Product Change Notification

Delay in CR123A Label and Packaging

CR123APA/B, CR-123ADT/1S, CR-123ADT2/B,
CR-123APA/5S

16th February 2022

Label Design

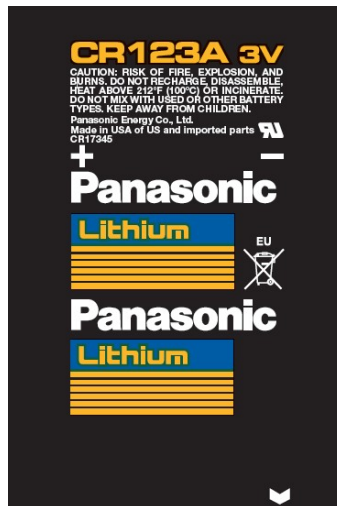
The company name will be changed from Panasonic Corporation to Panasonic Energy Co., Ltd on the current battery label and the carton labels.

The design of the Panasonic industrial CR123A label will change from the current black and gold to a gray and black design. This change will now happen in June or July instead of April 1st. This will match the current CR123A product produced by the Panasonic factory in Jakarta, Indonesia.

Packaging

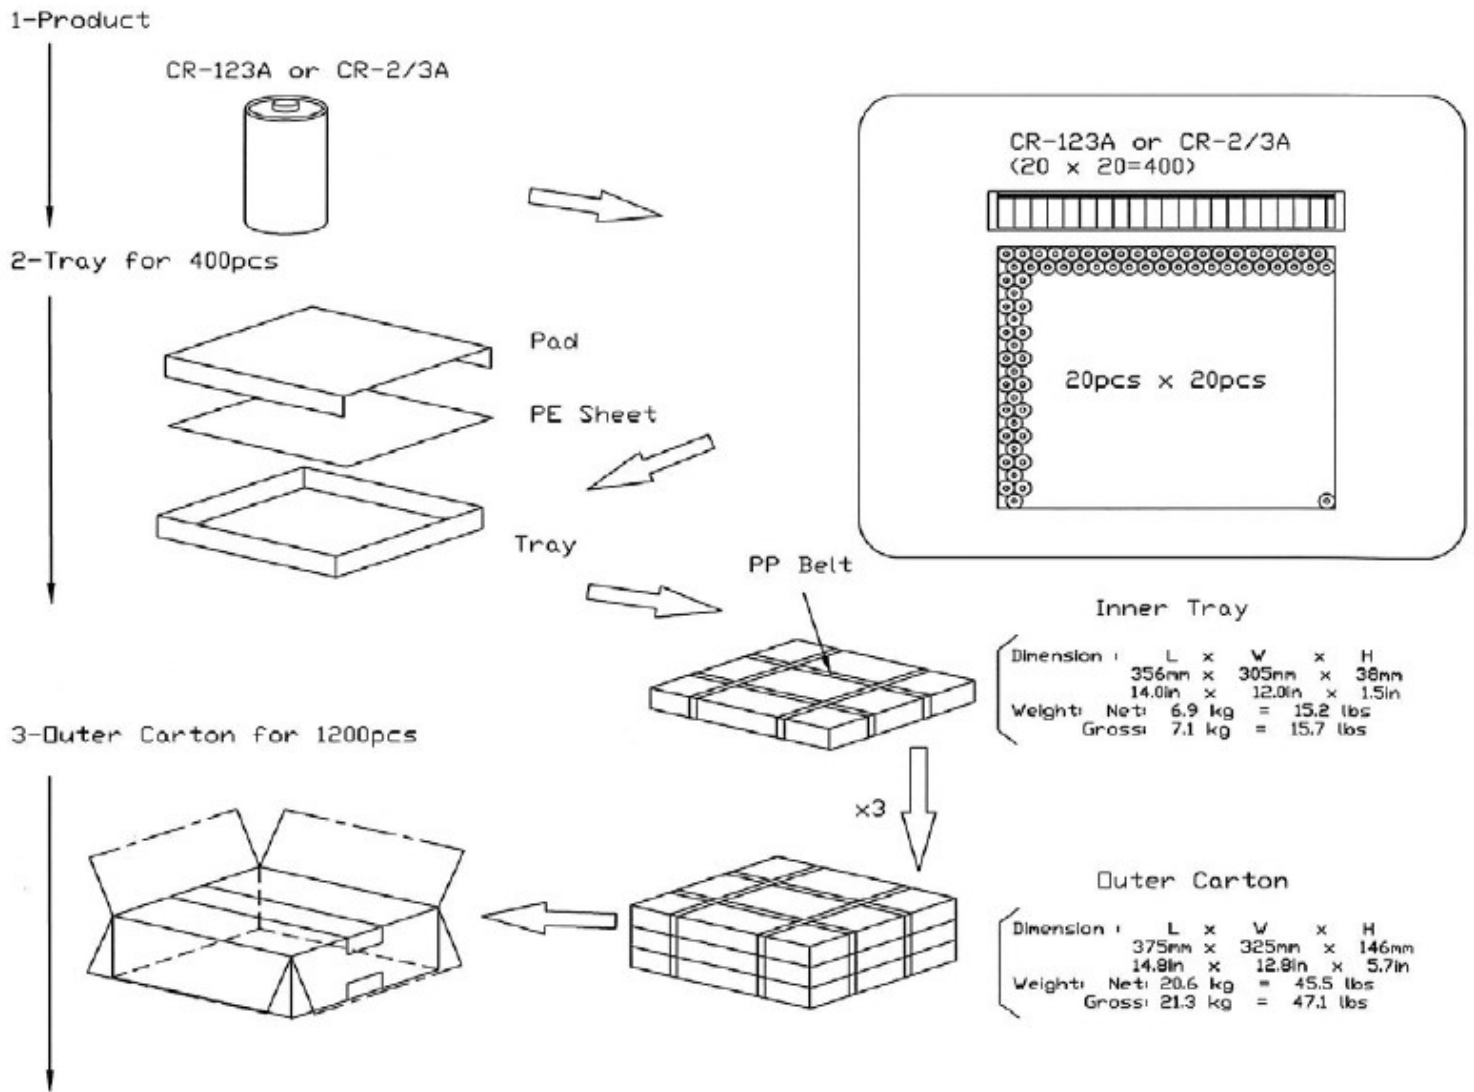
The current CR123A packaging still be used until the global label design change.

New Packaging

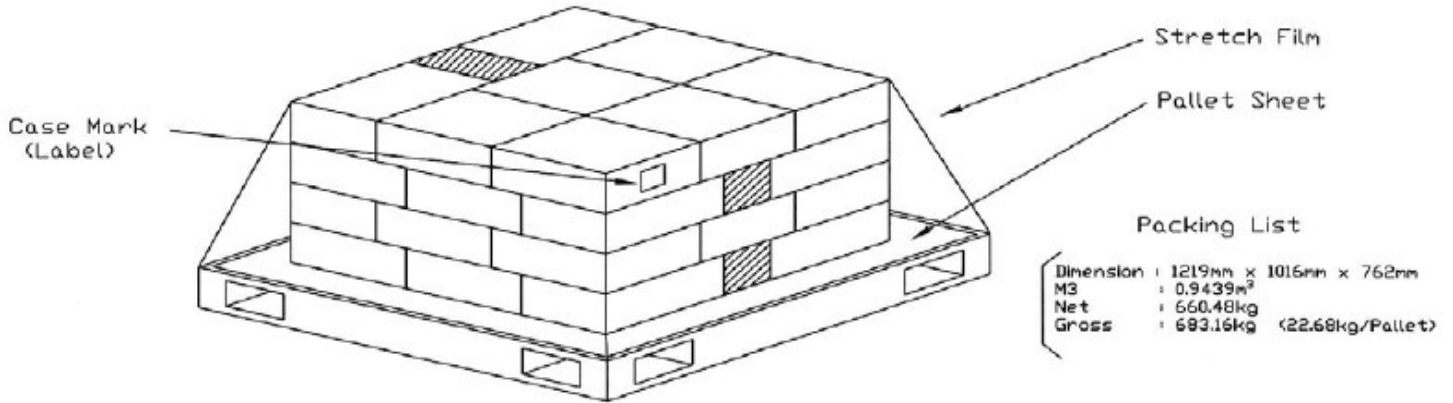
The CR123A packaging will be redesigned to improve the strength and drop test performance.
